Access Compliance Report Public Rights-of-Way (Curb Ramps)

Main Street: CURTIS_LN Cross Street: CLYDESDALE_DR Location: S

ADA ID: RPRK211112123059 Ramp Type: Type 4 - Parallel Initial Pass/Fail: Pass Overall Compliance: No Severity Score: 25

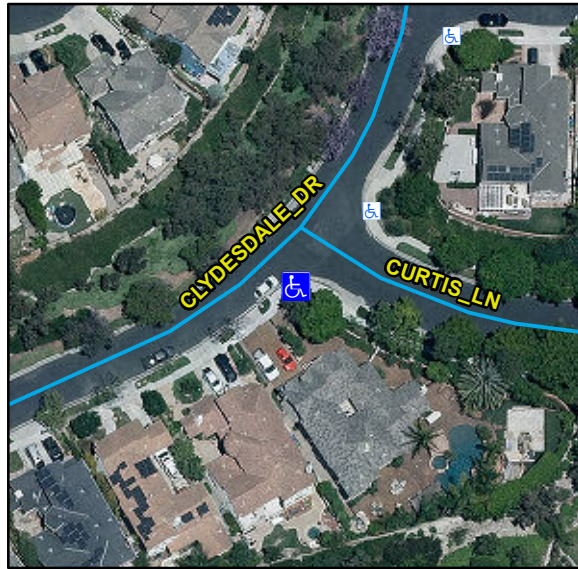
Compliance	Description	Data	Compliance	Description	Data
N/A	Ramp Length LT (in)	112	N/A	Ramp Length RT (in)	131
Yes	Ramp Width LT (in)	53	Yes	Ramp Width RT (in)	53
Yes	Ramp Run Slope LT (%)	4.3	Yes	Ramp Run Slope RT (%)	7
Yes	Ramp Cross Slope LT (%)	0.6	Yes	Ramp Cross Slope RT (%)	0.6
N/A	Landing Present	No	No	DWS Provided	No
N/A	Landing Length (in)	N/A	N/A	DWS Contrast	N/A
No	Landing Width (in)	N/A	N/A	DWS Length (in)	N/A
No	Landing Run Slope (%)	N/A	N/A	DWS Full Width	N/A
No	Landing Cross Slope (%)	N/A		DWS Offset Type	N/A
N/A	Landing Movement Obstructed?	No	N/A	DWS Offset Left (in)	N/A
	Landing Movement Type	Curb	N/A	DWS Offset Right (in)	N/A
N/A	Landing Shared	N/A			
N/A	Clear Space	Yes			
N/A	Clear Space To Crosswalk (in)	48			
N/A	Marked Crosswalk 1	No	N/A	Marked Crosswalk 2	No
	Crossing 1 Direction	NE		Crossing 2 Direction	NW
N/A	Marked Crosswalk 1 Width (in)	N/A		Marked Crosswalk 2 Width (in)	N/A
N/A	Ramp Inside Crosswalk 1	N/A	N/A	Ramp Inside Crosswalk 2	N/A

Crossing 1 Slope (%)	3.5		Crossing 2 Slope (%)	5.3
	Crossing 1 Cross Slope (%)	1.3		Crossing 2 Cross Slope (%)	0.2
Yes	Gutter Ponding	No	No	Curb Slope	9.1
Yes	Gutter Lip Height (in)	0		Road Run Slope (%)	3.6
No	Gutter Run Slope (%)	10		Road Cross Slope (%)	6.3
Yes	Gutter Cross Slope (%)	1	No	Perpendicular Joint Present	No
Yes	Overall Surface Condition	Acceptable			
	Cross Gutter Present?	No		Spandrel Present?	No
	Replace Cross Gutter?	N/A		Replace Spandrel?	N/A

Remove & Replace Curb Ramp With Two New Directional Ramps or Equivalent. Remove & Replace Gutter.
